NFPA 805 Frequently Asked
Questions Program
Public Meeting
July 20, 2006

Charles Moulton
Fire Protection Engineer, AFPB

NATIONAL FIRE PROTECTION ASSOCIATION STANDARD 805 FREQUENTLY ASKED QUESTIONS PROGRAM

Figure B-1 – Process for Determining if an Active Fire Protection Feature is Required for NFPA 805 Chapter 4 Compliance

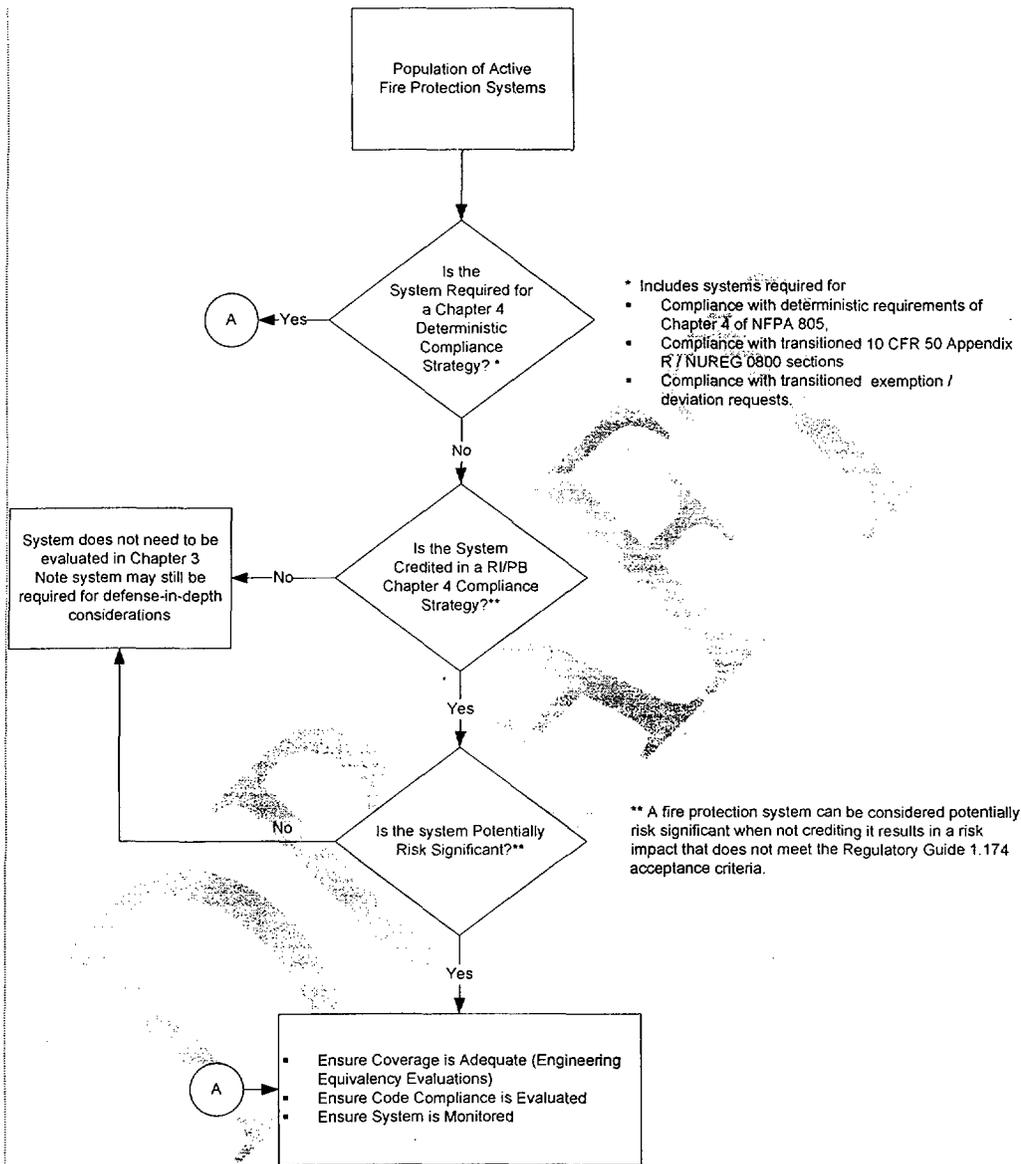
Comment: Acceptance criteria must be included in the licensee's fire protection license condition and must be in accordance with RG 1.205, not RG 1.174 (unless alternative criteria are submitted and approved by the NRC).

Figure B-2 – Process for Determining if an ERFBS is Required for NFPA 805 Chapter 4 Compliance

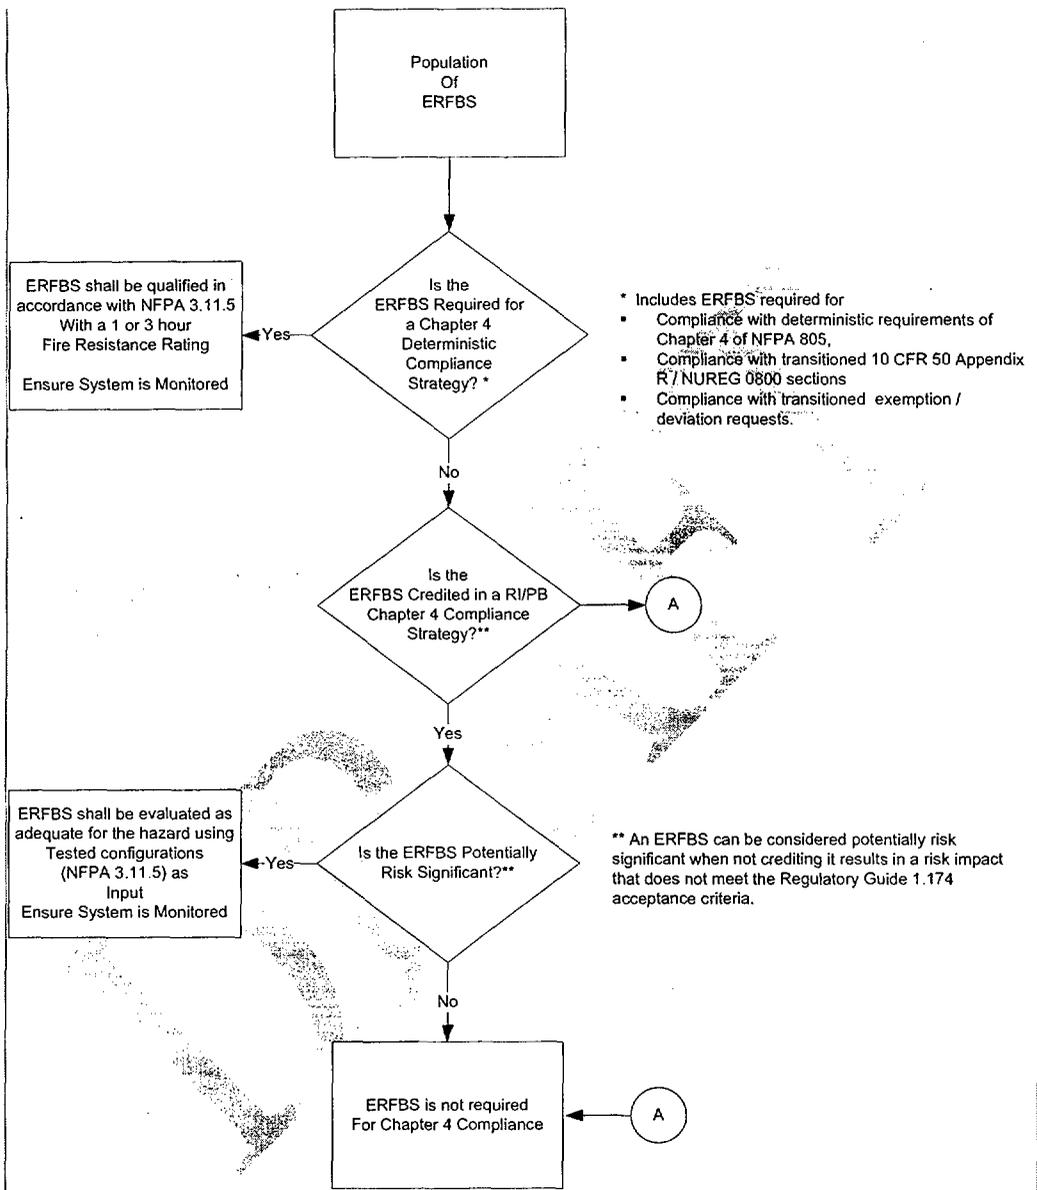
Comment: See comment above on risk acceptance criteria.
